Virgil C. Summer Nuclear Station (VCSNS) Units 2 and 3
Combined License Nos. NPF-93 and NPF-94
Docket Nos. 52-027 & 52-028

Subject: LAR 16-10 License Amendment and Exemption Request: Shield Building Roof Changes

- Enclosure 1: Virgil C. Summer Nuclear Station Units 2 and 3 – Request for License Amendment Regarding Shield Building Roof Changes (LAR 16-10)
- Enclosure 2: Virgil C. Summer Nuclear Station Units 2 and 3 – Protected Information for Request for License Amendment Regarding Shield Building Roof Changes (LAR 16-10) – Security-Related Information – **Withhold from Public Disclosure Under 10 CFR 2.390(d)**
- Enclosure 3: Virgil C. Summer Nuclear Station Units 2 and 3 – Exemption Request Regarding Shield Building Roof Changes (LAR 16-10)
- Enclosure 4: Virgil C. Summer Nuclear Station Units 2 and 3 – Proposed Changes to Licensing Basis Documents (LAR 16-10)
- Enclosure 5: Virgil C. Summer Nuclear Station Units 2 and 3 – Proposed Changes to Licensing Basis Documents – Protected Information (LAR 16-10) – Security-Related Information – **Withhold from Public Disclosure Under 10 CFR 2.390(d)**

UFSAR Table 3H.5-9 (Sheet 2b of 3) Shield Building Roof Reinforcement Summary (Air Inlet) - Revise information as shown below (figure blow-up is shown on the following pages).

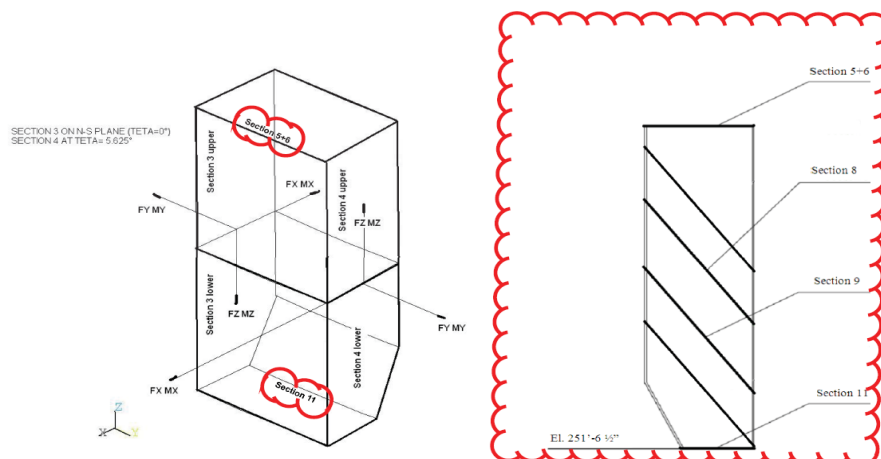
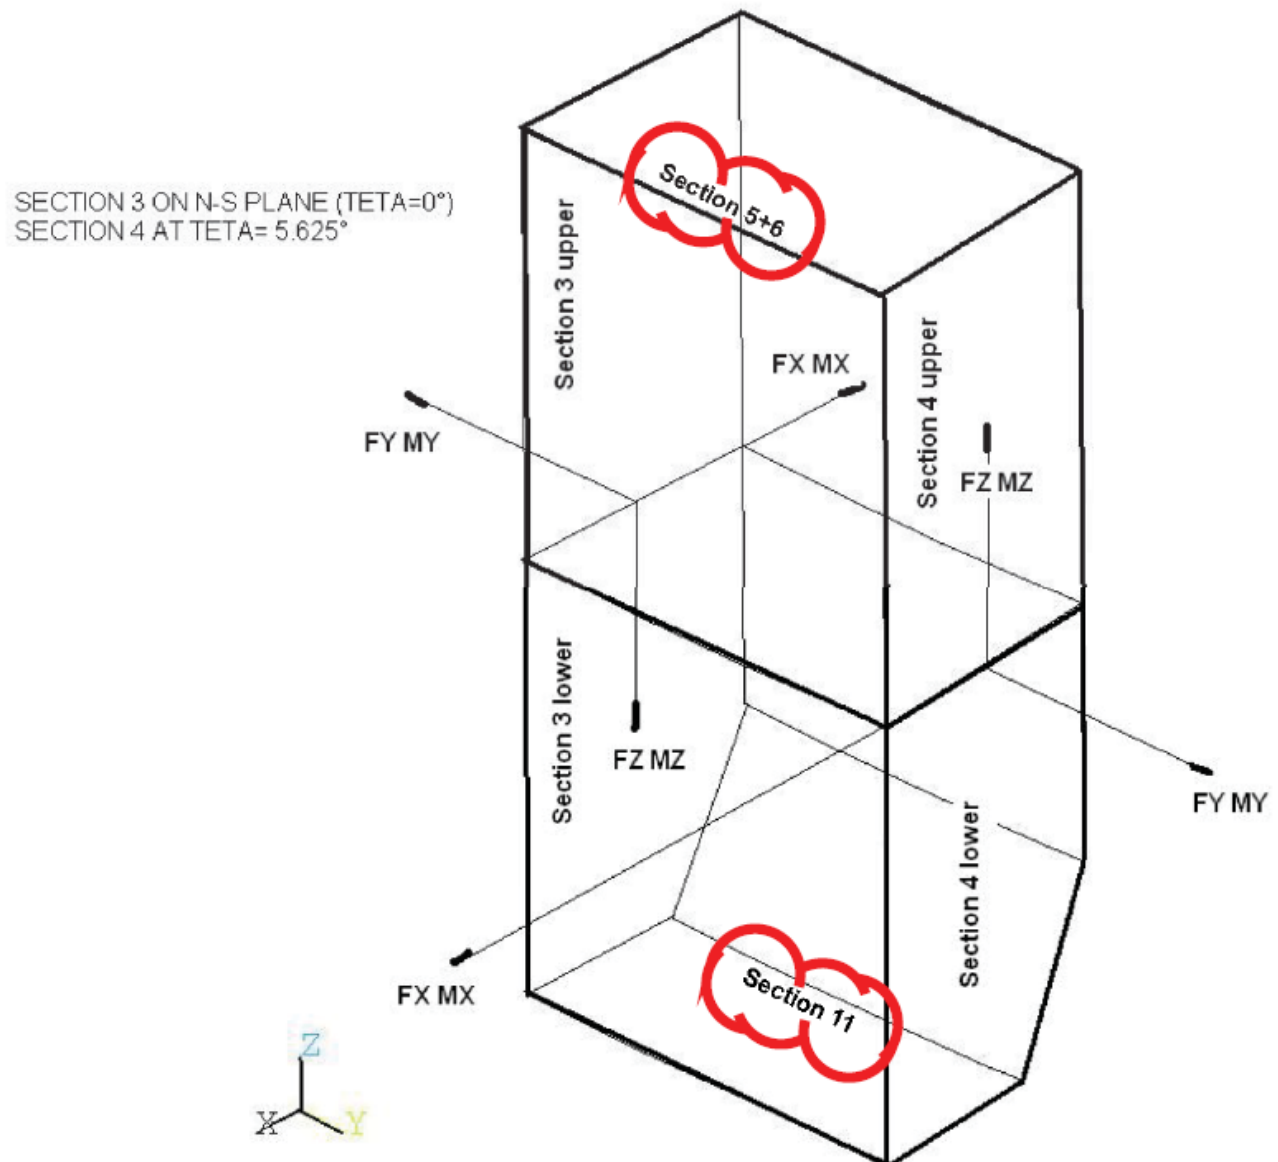
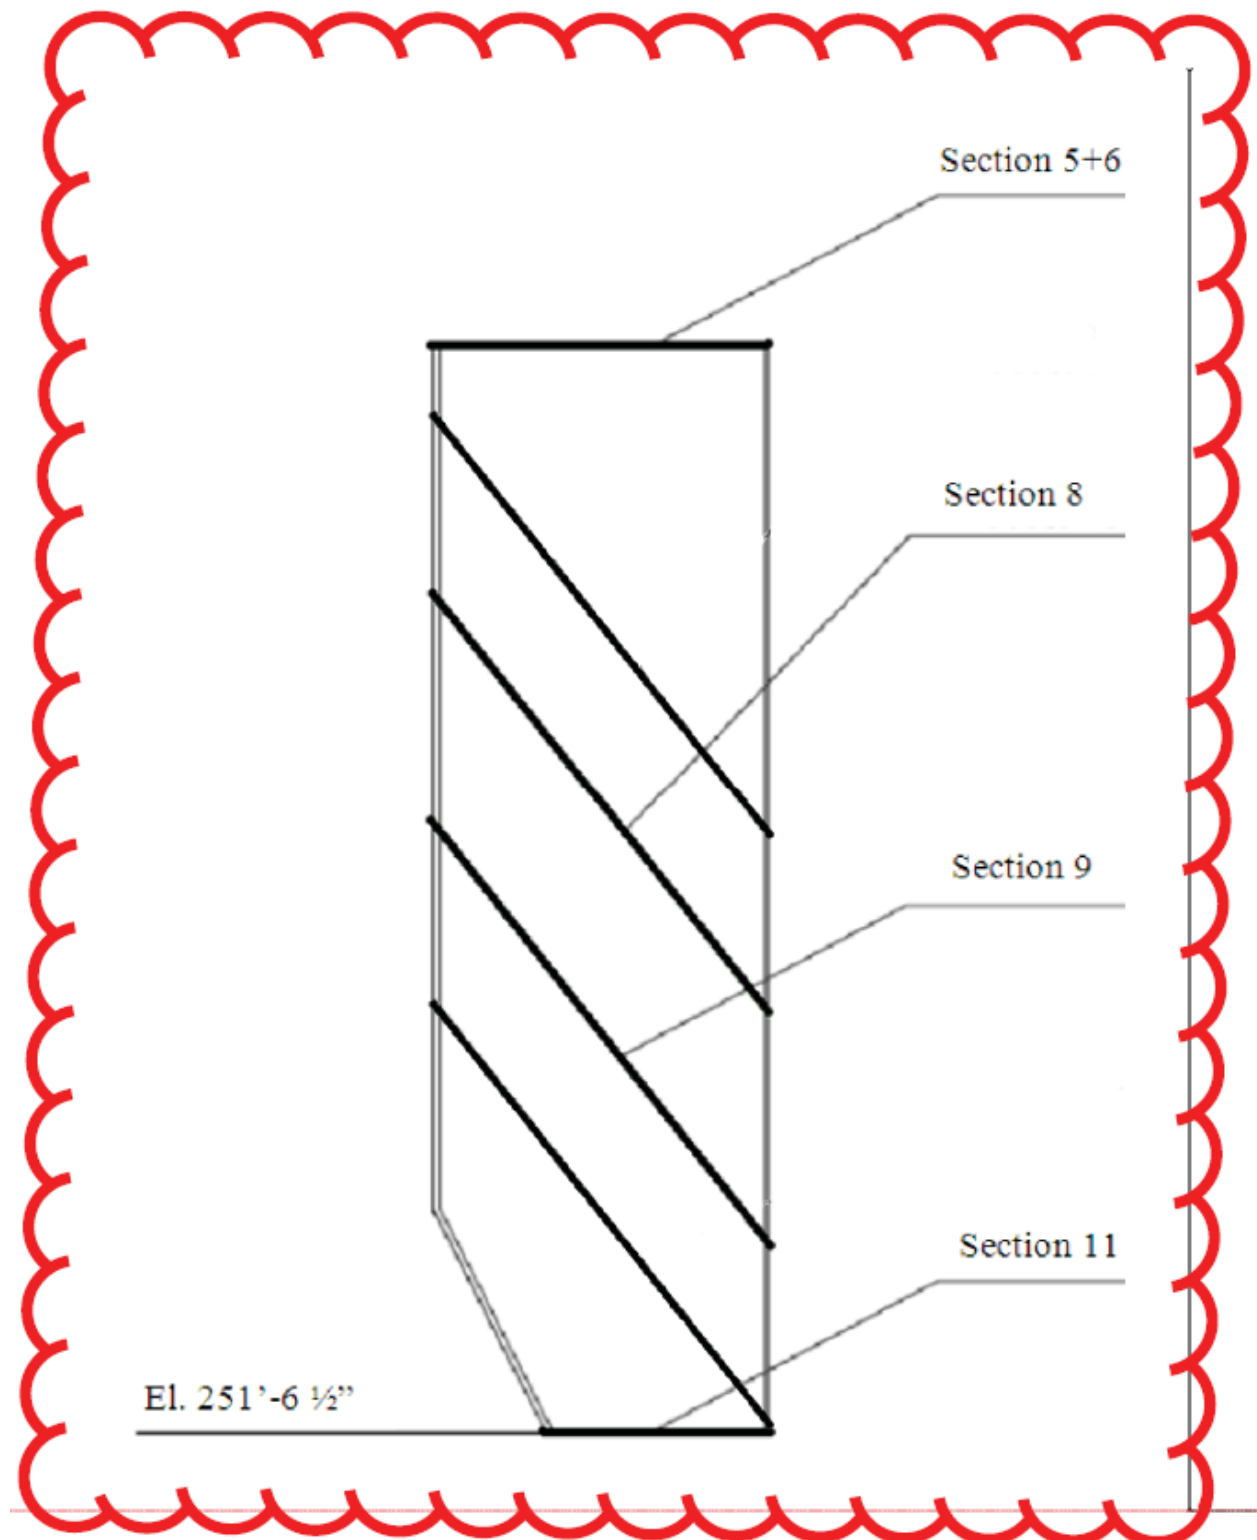
1. Revise values in table and the numbers of governing load combinations. CA#3
2. Remove dimensions from the locator figures. CA#4A
3. Add a legend to the table sketches to identify the location of the sections. CA#4A
4. The tie bar is renamed. CA#4D
